Project	IEEE 802.16 Broadband Wireless Access Working Group < http://ieee802.org/16 >
Title	Fix the problem of Pilot Allocation in Downlink PUSC and FUSC for 3Tx Antennas
Date Submitted	2005-07-14
Source(s)	Jane (Jie) Li, William (Xinhao) Cheng, Michael (Jibin) Wang, mailto:john_lee@huawei.com Henry Horng, Mattias Wennstrom, Phillip Barber, Jim Carlo, David Xiang, Duke Dang, Lucy Chen, John Lee HUAWEI
Re:	Call for contribution and comments.
Abstract	Fix the problem of Pilot Allocation in Downlink PUSC and FUSC for 3Tx Antennas.
Purpose	Adoption
Notice	This document has been prepared to assist IEEE 802.16. It is offered as a basis for discussion and is not binding on the contributing individual(s) or organization(s). The material in this document is subject to change in form and content after further study. The contributor(s) reserve(s) the right to add, amend or withdraw material contained herein.

Fix the problem of Pilot Allocation in Downlink PUSC and FUSC for 3Tx Antennas

Fig.1 proposed pilot allocation scheme for 3Tx in PUSC

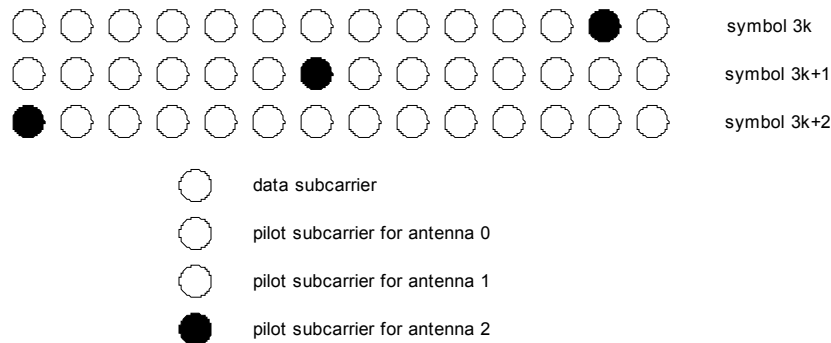
In PUSC mode, the proposed pilot allocation scheme is illustrated in Figure 1. In each symbol of a cluster, the 1st and 13th subcarriers are reserved for pilot subcarriers. The data subcarriers which overlap with the pilots are replaced with pilots, i.e. the 7th subcarriers in each symbol of a cluster are replaced with pilots. The pilot locations change in period of three symbols.

Fig.2 proposed STC usage with FUSC

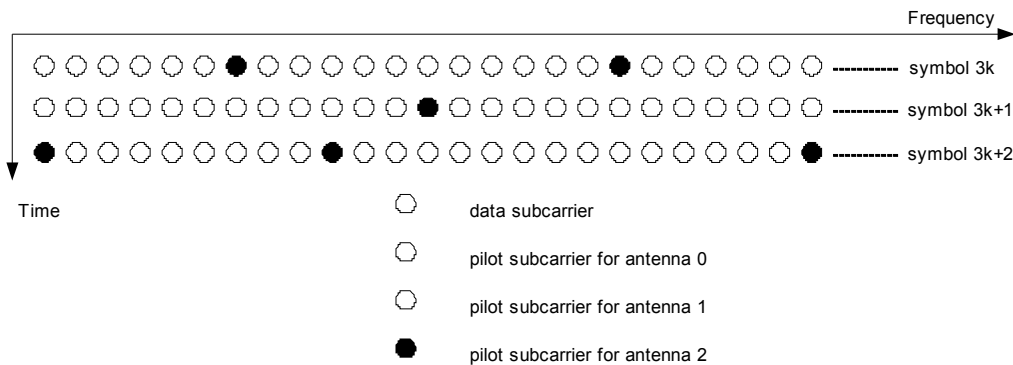
Similar to the structures for two and four antenna cases in IEEE P802.16-2004/Cor1/D3, the pilots in FUSC shall be transmitted with a structure including three times symbols (repeating itself every three symbols) as follows:

Symbol 3k: antenna 0 uses VariableSet#0 and ConstantSet#0, antenna 1 uses VariableSet#1 and ConstantSet#1, antenna 2 uses (VariableSet#0+6) and (VariableSet#1+6).

Symbol 3k+1: antenna 0 uses (VariableSet#0+6) and (VariableSet#1+6), antenna 1 uses VariableSet#0 and ConstantSet#0, antenna 2 uses VariableSet#1 and ConstantSet#1.

Symbol 3k+2: antenna 0 uses VariableSet#1 and ConstantSet#1, antenna 1 uses (VariableSet#0+6) and (VariableSet#1+6), antenna 2 uses VariableSet#0 and ConstantSet#0.

Figure 2 shows the STC usage in FUSC mode. For this configuration, in each symbol, the pilot locations listed in Tables 311 of IEEE P802.16e/D9 are reserved for pilot subcarriers. The data subcarriers which overlap with the pilots shown in Fig.2 are replaced with pilots, i.e. the subcarriers defined in (VariableSet#0+6) and (VariableSet#1+6) in each symbols are replaced with pilots.

Figure 251a Cluster structure for STC PUSC using 3 Antennas

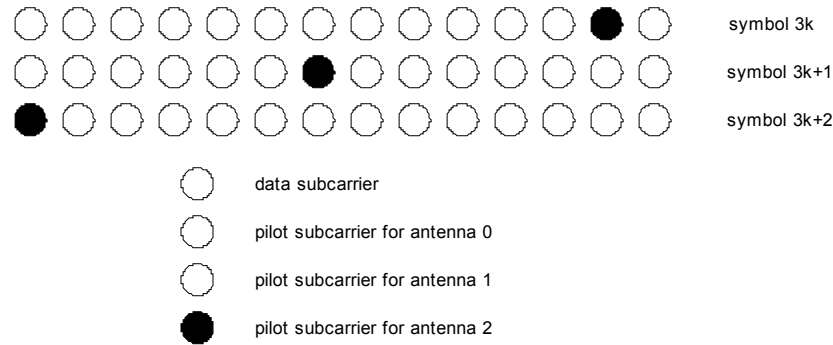
[Insert a new section 8.4.8.2 in page436 line 31 and renumber all subsequent sections accordingly]

For this configuration, the basic cluster structure is changed (as indicated in Figure 251a) to accommodate the transmission from three antennas. In each symbol, 1st and 13th subcarriers in each cluster are the reserved pilot subcarriers. The data subcarriers which overlap with the pilots indicated in figured 251a are replaced with pilots, i.e. 7th subcarriers in each symbol of a cluster are replaced with pilots. The data puncturing for CC or the data truncation for CTC shall be performed after STC encoding and before IFFT subcarrier mapping.

Figure 251b STC usage with FUSC

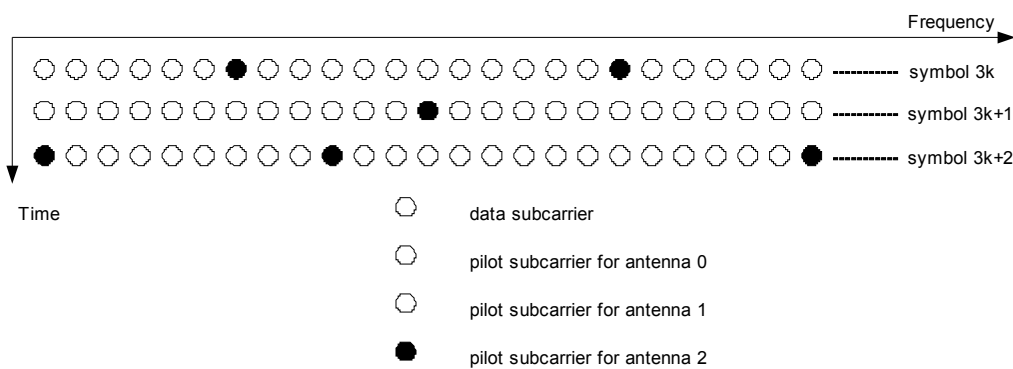
For the FUSC configuration, the pilots embedded within the symbol shall be further divided. The pilots shall be transmitted with a structure including three times symbols (repeating itself every three symbols) as follows:

Symbol 3k: antenna 0 uses VariableSet#0 and ConstantSet#0, antenna 1 uses VariableSet#1 and ConstantSet#1, antenna 2 uses (VariableSet#0+6) and (VariableSet#1+6).

Symbol 3k+1: antenna 0 uses (VariableSet#0+6) and (VariableSet#1+6), antenna 1 uses VariableSet#0 and ConstantSet#0, antenna 2 uses VariableSet#1 and ConstantSet#1.

Symbol 3k+2: antenna 0 uses VariableSet#1 and ConstantSet#1, antenna 1 uses (VariableSet#0+6) and (VariableSet#1+6), antenna 2 uses VariableSet#0 and ConstantSet#0.

For this configuration, in each symbol, the pilots location listed in Table 311 are the reserved pilot subcarriers. The data subcarriers which overlap with the pilots indicated in figured 251b are replaced with pilots, i.e. the subcarriers (VariableSet#0+6) and (VariableSet#1+6) in each symbols are replaced with pilots. The data puncturing for CC or the data truncation for CTC shall be performed after STC encoding and before IFFT subcarrier mapping.
